Product Change Notification / SYST-31HPWF472

ERRATA - dsPIC33CH128MP508 Family Silicon Errata and Datasheet Clarification

dsPIC33CH128MP508 Family Silicon Errata and Data Sheet Clarification

FIGURE 1: I/O RAMP

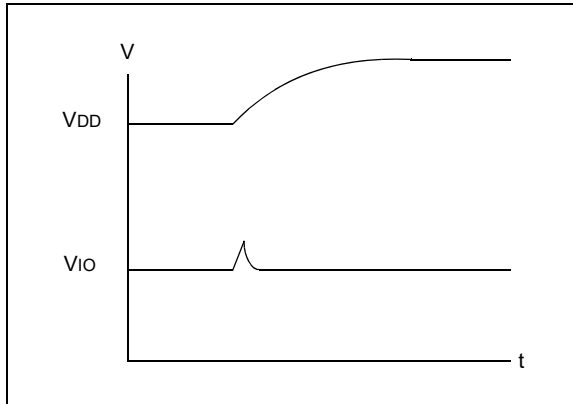
During a fast device power-up, when the VDD ramp is less than 4 mS, the I/O pins may drive up to 100 μ A current for a duration of up to 10 μ S (Figure 1).

1. Slow down the VDD ramp time (greater than 4 mS for VDD to ramp 0V to 3.3V).
2. Ensure the circuitry that is connected to the pins can endure this pulse.

High-voltage applications with complementary switches should power the high-voltage 200 μ Sec later than powering the dsPIC[®] device to avoid the current shoot-through. This behavior is specific to each device and not affected by aging.

FIGURE 2-2: SUGGESTED PLACEMENT OF THE OSCILLATOR CIRCUIT

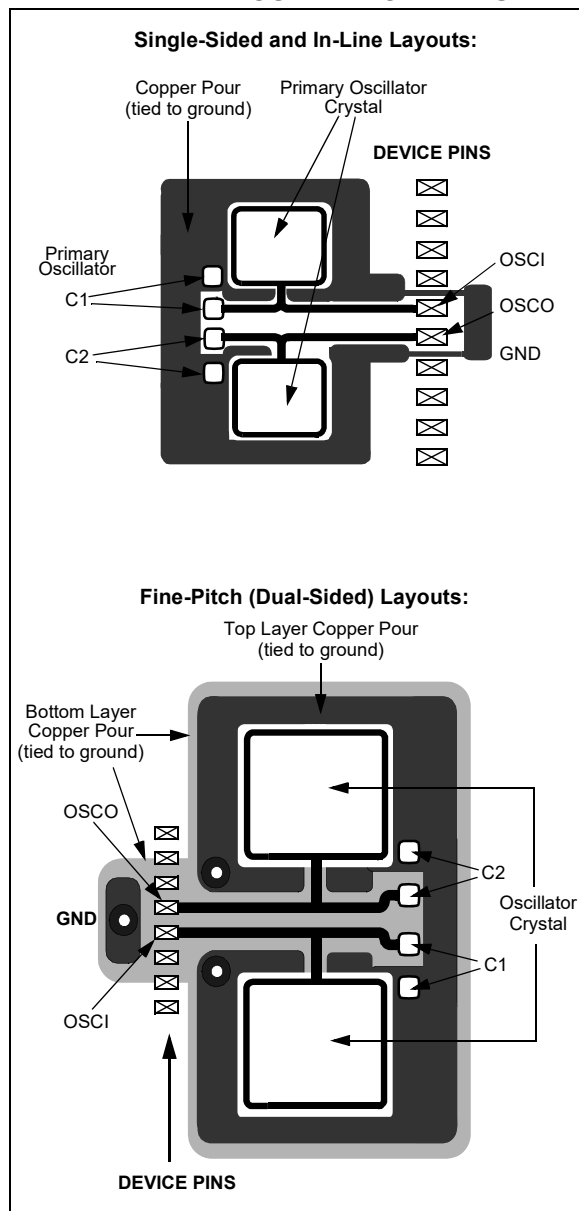
Additional information is added to [Section 2.5 “External Oscillator Pins”](#) and [Section 2.6 “External Oscillator Layout Guidance”](#) is added.

Use best practices during PCB layout to ensure robust start-up and operation. The oscillator circuit should be placed on the same side of the board as the device. Also, place the oscillator circuit close to the respective oscillator pins, not exceeding one-half inch (12 mm) distance between them. The load capacitors should be placed next to the oscillator itself, on the same side of the board. Use a grounded copper pour around the oscillator circuit to isolate it from surrounding circuits. The grounded copper pour should be routed directly to the MCU ground. Do not run any signal traces or power traces inside the ground pour. If using a two-sided board, avoid any traces on the other side of the board where the crystal is placed. Suggested layouts are shown in [Figure 2-2](#). With fine-pitch packages, it is not always possible to completely surround the pins and components. A suitable solution is to tie the broken guard sections to a mirrored ground layer. In all cases, the guard trace(s) must be returned to ground.

FIGURE: ADC ANALOG INPUT MODEL

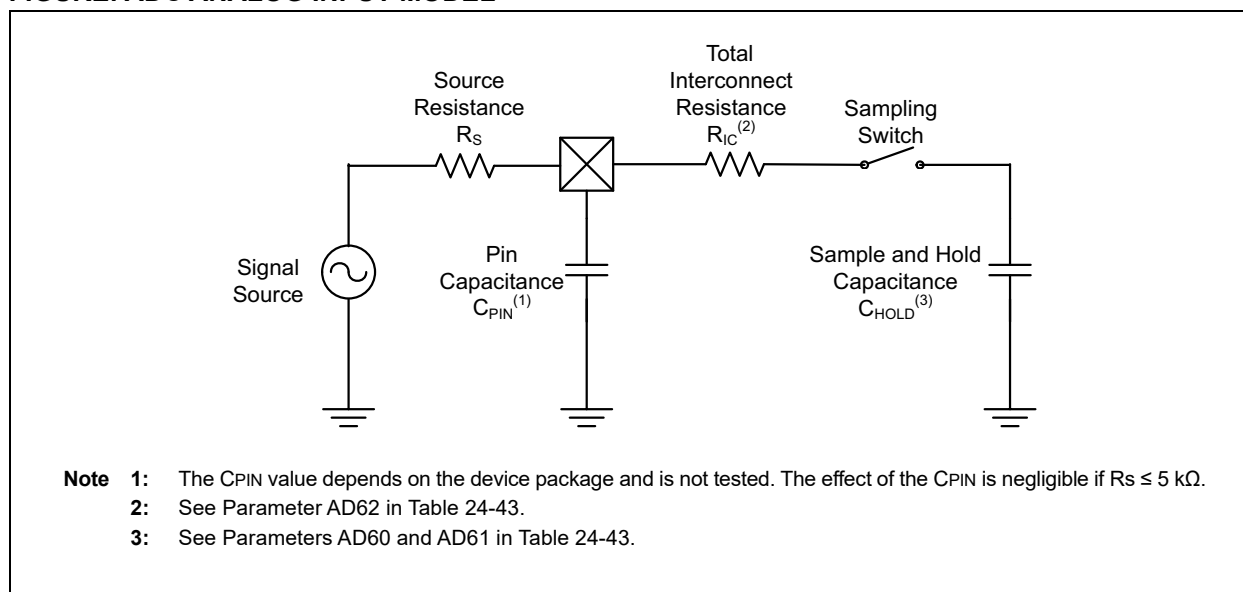
The following [Sampling Time Requirements](#) section has been added to both **Section 3.9 “High-Speed, 12-Bit Analog-to-Digital Converter (Main Core ADC)”** and **Section 4.7 “High-Speed, 12-Bit Analog-to-Digital Converter (Secondary Core ADC)”**.

The total acquisition time for the Analog-to-Digital conversion is a function of the Holding Capacitor (C_{HOLD}) charge time. For the ADC module to meet its specified accuracy, the Holding Capacitor (C_{HOLD}) must be allowed to fully charge to the voltage level on the analog input pin. The Signal Source Impedance (R_s)

and the Interconnect Impedance (R_{IC}) combine to affect the time required to charge the C_{HOLD} . The total resistance ($R_s + R_{IC}$) must therefore, be small enough to fully charge the Holding Capacitor within the selected sample time.
